HISTORIC AND DESIGN REVIEW COMMISSION

July 17, 2024

HDRC CASE NO: 2024-226
ADDRESS: 145 GREENLAWN
LEGAL DESCRIPTION: NCB 8417 BLK 2 LOT 35
ZONING: R-5, H
CITY COUNCIL DIST.: 1
DISTRICT: Greenlawn Estates Historic District
APPLICANT: Benedict Torres
OWNER: Benedict Torres
TYPE OF WORK: Dormer installation
APPLICATION RECEIVED: June 11, 2024
60-DAY REVIEW: August 10, 2024
CASE MANAGER: Claudia Espinosa

The applicant is requesting a Certificate of Appropriateness for approval to install two dormers of the south-facing (front elevation) roof form.

2 Proposed
Dormers

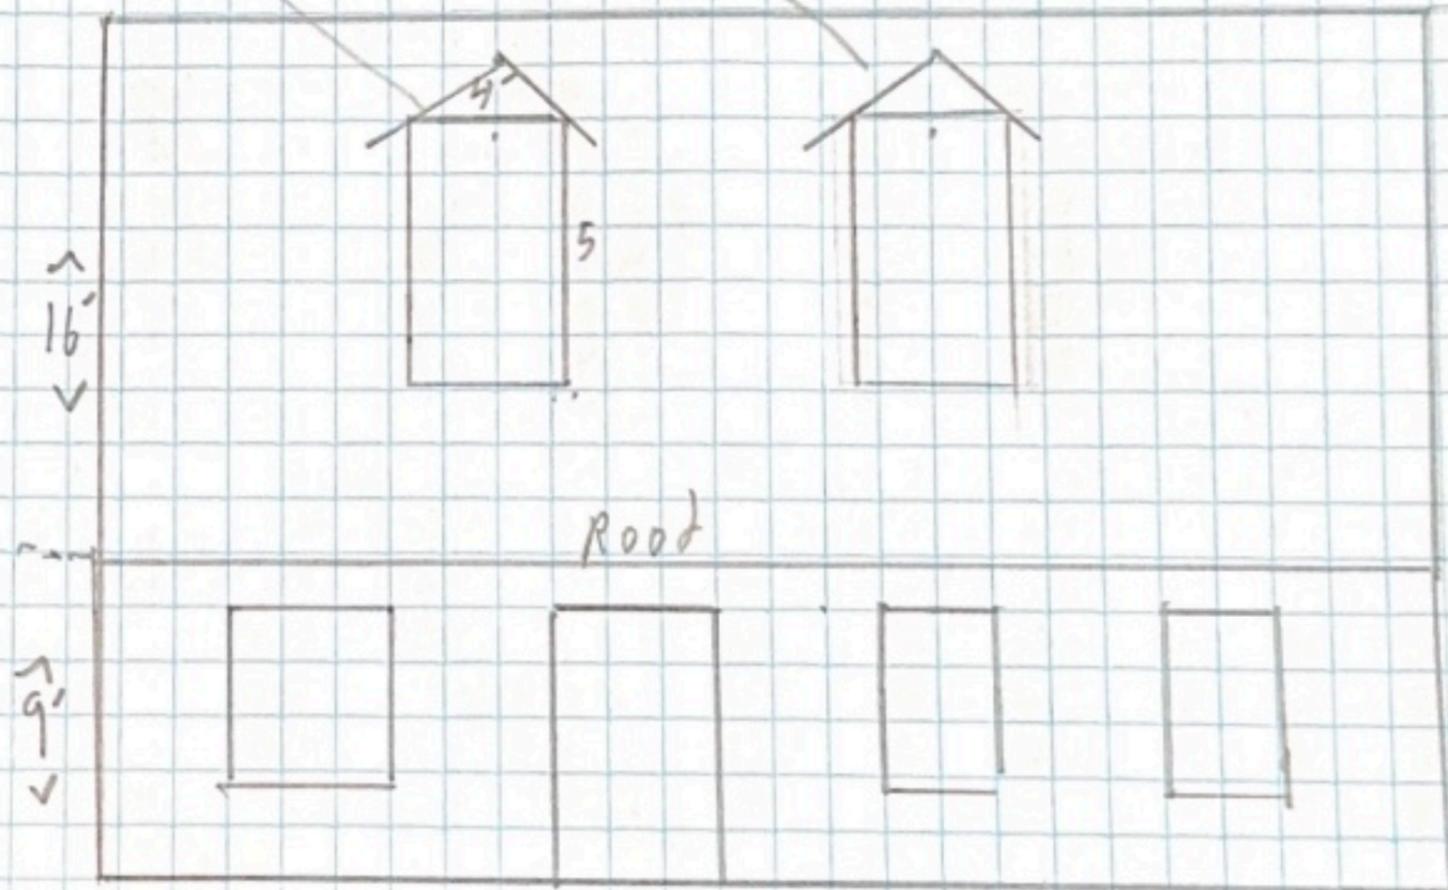
- b. **ROOF FORM MODIFICATIONS (FRONT ELEVATION)**— The applicant has proposed to construct two dormers on the front facade (south elevation) of the historic structure. The Guidelines for Additions 1. B.iii., state to ensure dormers are compatible in size, scale, proportion, placement, and detail with the style of the house. Locate dormers only on non-primary facades (those not facing the public right-of-way) if not historically found within the district. Staff finds the installation of dormers to the front facade (facing the ROW) creates a false sense of historical appearance and is inconsistent with the guidelines.

Staff does not recommend approval of the installation of two dormers on the front facade based on finding b.
